**Re: TransPort Colorado: Master Plan Sub-Area #1 (Tab #5)  
Response to 5<sup>th</sup> Comments for 6<sup>th</sup> Submittal (Technical)**

**TRANSPORT COLORADO**  
**PUBLIC IMPROVEMENT PLAN**  
**SUB-AREA 1**

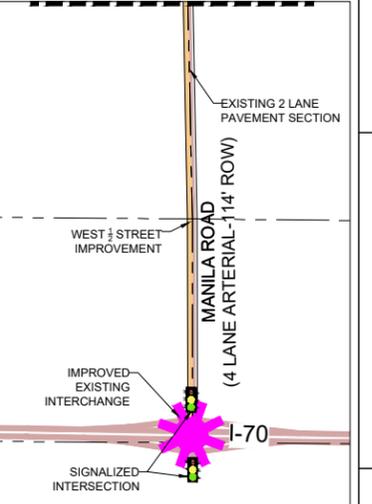
Change this to "Open Channel/Stream Management Corridor"

Legend was updated to "OPEN CHANNEL/STREAM MANAGEMENT CORRIDOR"

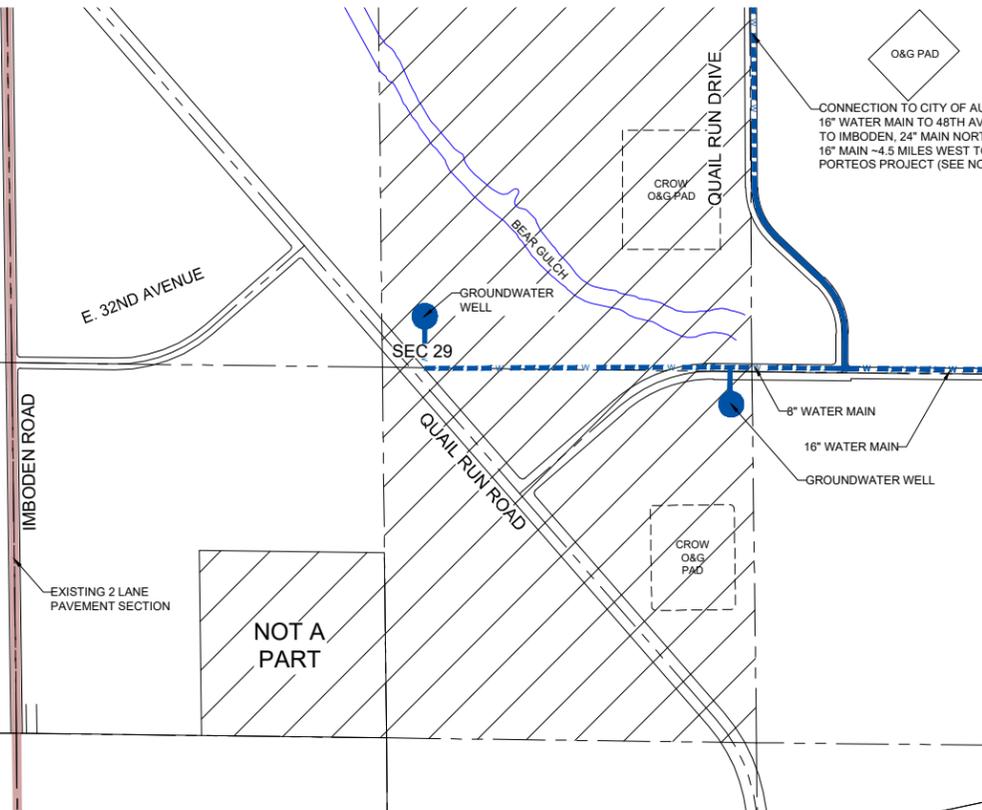
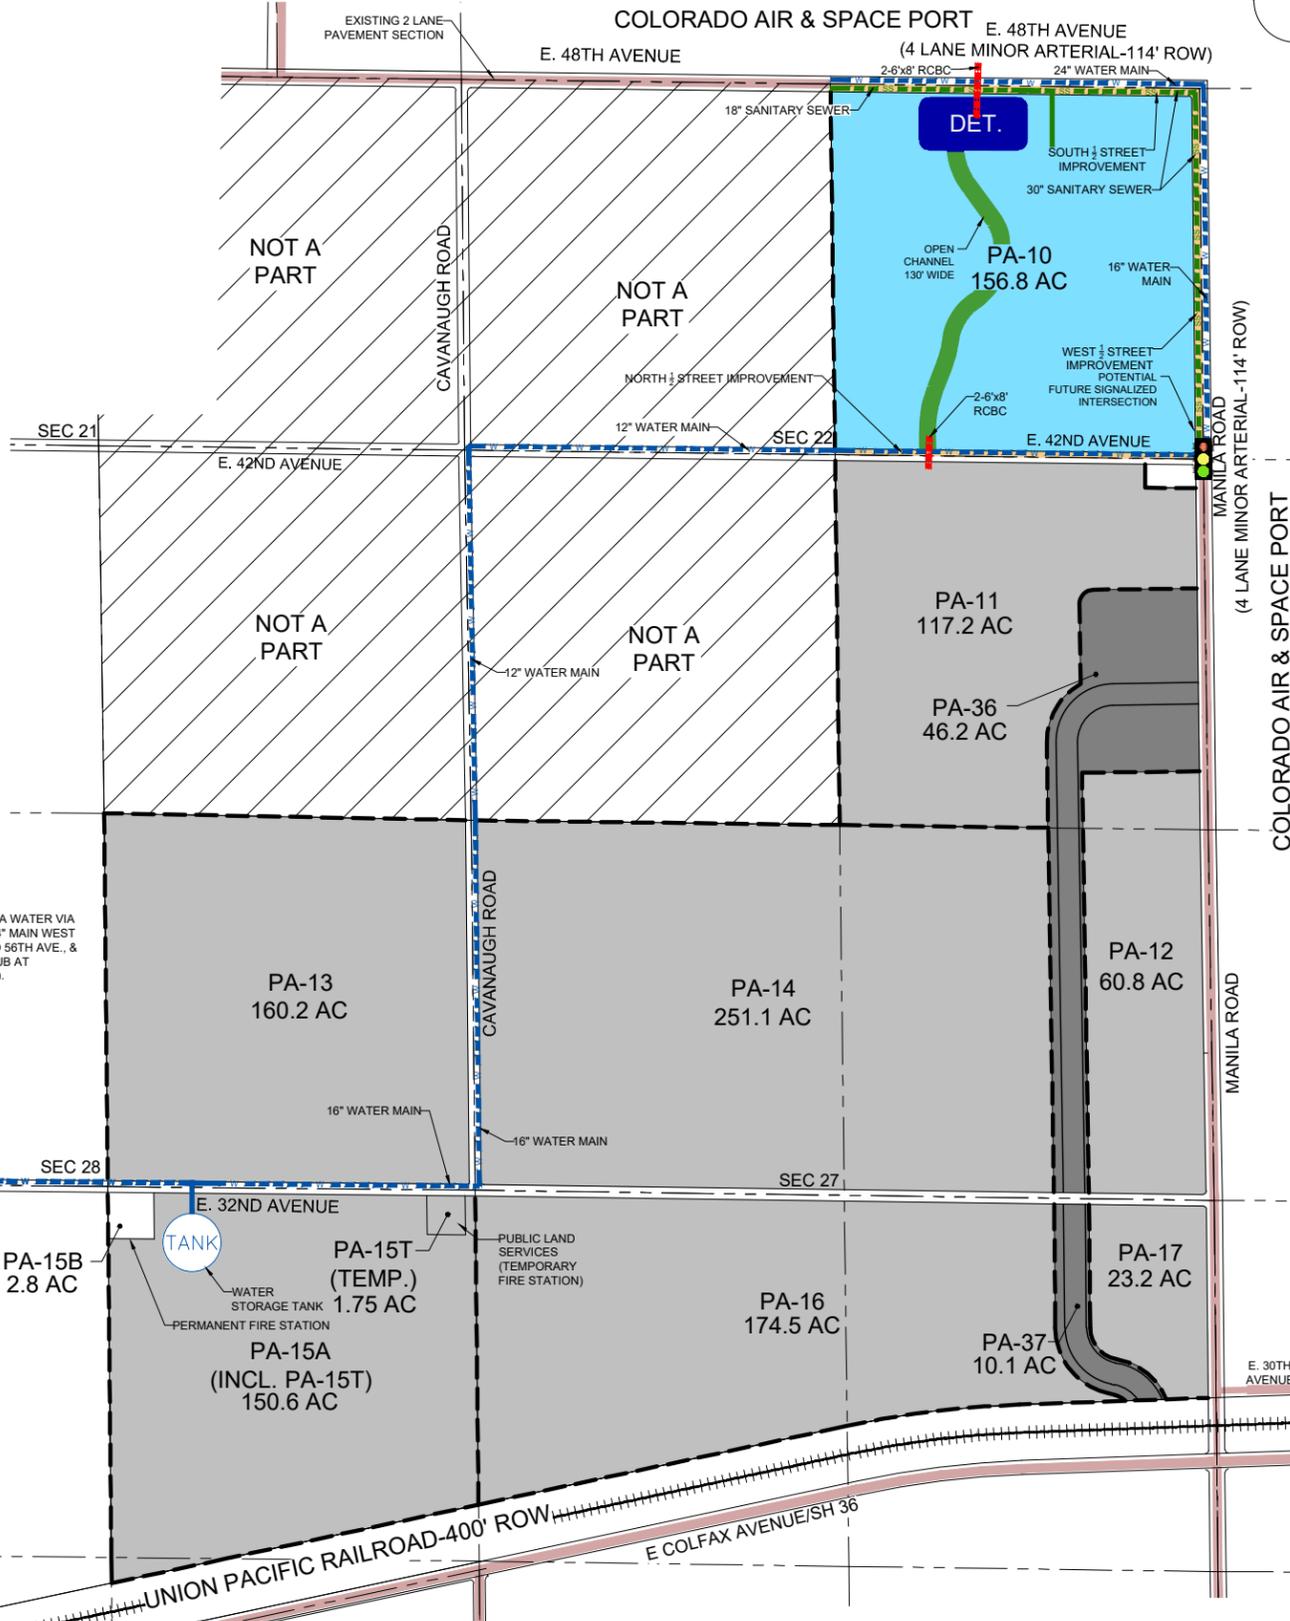
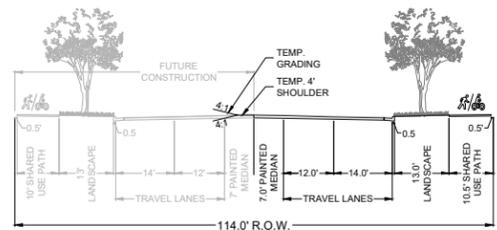
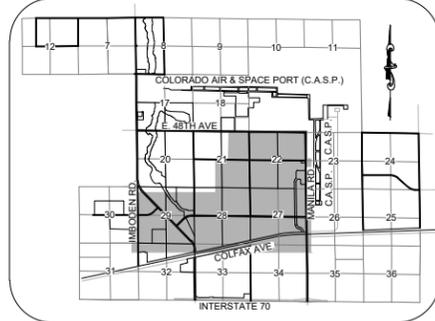
Sheet 1 of PIP

4F. Constructed regional channel alignments will generally follow the alignments of the existing drainageways. **RE: Note 11 has been updated per city comment.**

4G. Add another note: Development of significant areas could trigger the requirement for construction of off-site channel or detention improvements. The need for off-site drainage improvements shall be evaluated by the City of Aurora and MHFD at the time the preliminary drainage report and plans are being developed. The Developer is encouraged to coordinate with the City and MHFD at the earliest possible time on required drainage improvements. It is recommended that this coordination occur before making the first submittal of a preliminary drainage report. **RE: Note 11 has been updated per city comment.**

4H. Revise note 13 as follows: An approved floodplain development permit is required for any work within a mapped 100-year floodplain. An approved no-rise certification and/or CLOMR is required for any work within a mapped floodway. Additional requirements may be requested by the floodplain administrator. **RE: Completed**

4I: Please remove all references to size of culverts and width of channel sections and add a note to refer to the master drainage study for conceptual sizes. **RE: Storm drainage system sizing has been removed from the report. This report currently references the Master Drainage Report.**

Storm drainage system sizing has been removed from the report. This report currently references the Master Drainage Report
